Model 250R/RX

Bevel gear

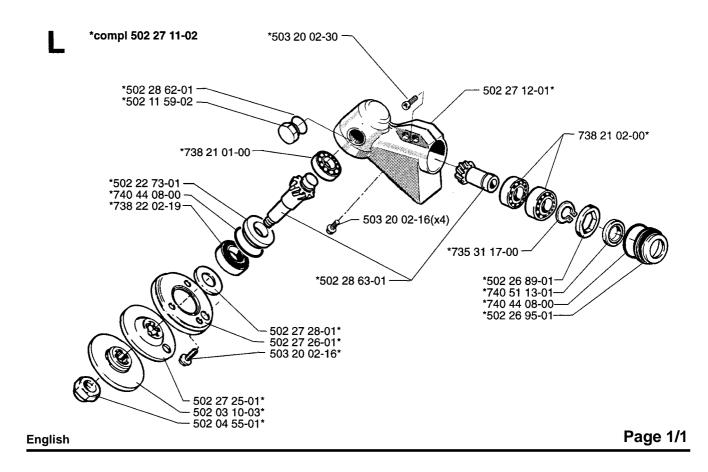
To reduce the operating temperature of the gear unit the sealing ring has been removed. This has been replaced with a sealing collar and O-ring. The gear unit assembly retains the same reference number 502 27 11-02.

New ref. no.	Description		Old ref. no.	Remarks
502 22 73-01	Sealing collar			
740 44 08-00	O-ring 29.2 x 3			
	Sealing ring		740 51 41-00	
Effective from serial number:		7100065	250RX	
		7100122	250R

Other reference numbers remain unchanged.
